## Amendment No. 001 Herbert Hoover National Historic Site Project PRA-HEHO 10(1), 100(1) DTFH71-08-B-00008

The purpose of this Amendment is to:

- 1) Revise the Special Contract Requirements (J-pages) as follows:
  - a) Section 572 to revise the hydrodemolition water pressure requirements.
- 2) Revise the Plans to clarify limits of concrete removal.

BRIDGE DECK DETAILS

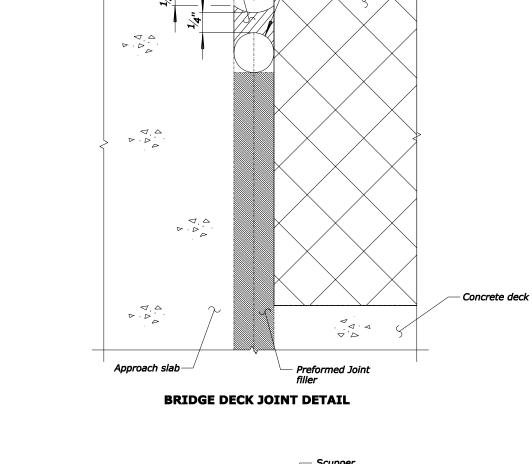
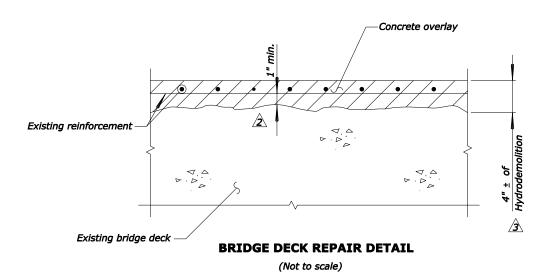
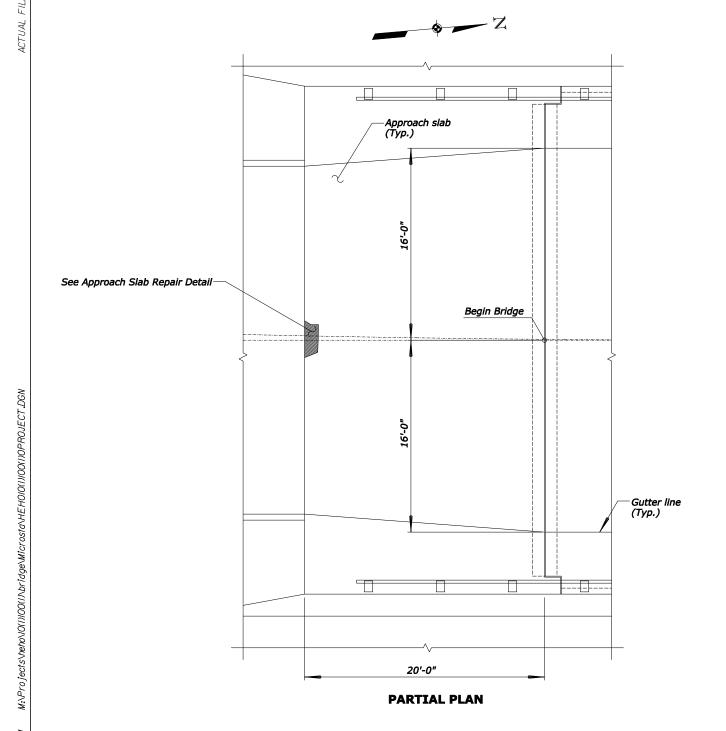
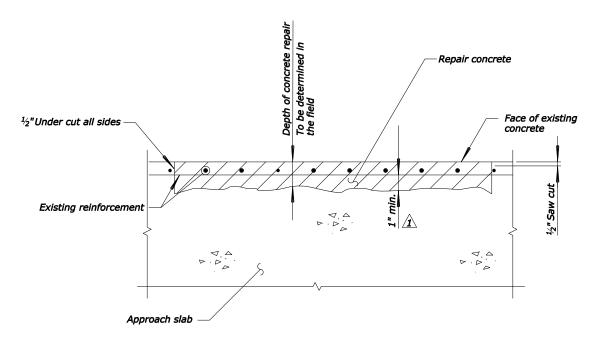
1. Delete Plan Sheets R04 and R13 and substitute revised Plan Sheets R04 and R13.

1. Remove top portion of existing bridge deck concrete to 1" min. below top mat of reinforcing steel.

NO. DATE REVISIONS DESIGNED BY DRAWN BY CHECKED BY SCALE PROJECT TEAM LEADER BRIDGE DRAWING DRAWING NO. REVISIONS NO. DATE DATE 4/1/08 CHANGE TO " I" min. CHANGE TO " ± ' MRC EMA No Scale Mark Clabaugh 4 of 17 January 2008 CHANGE TO "I" min."
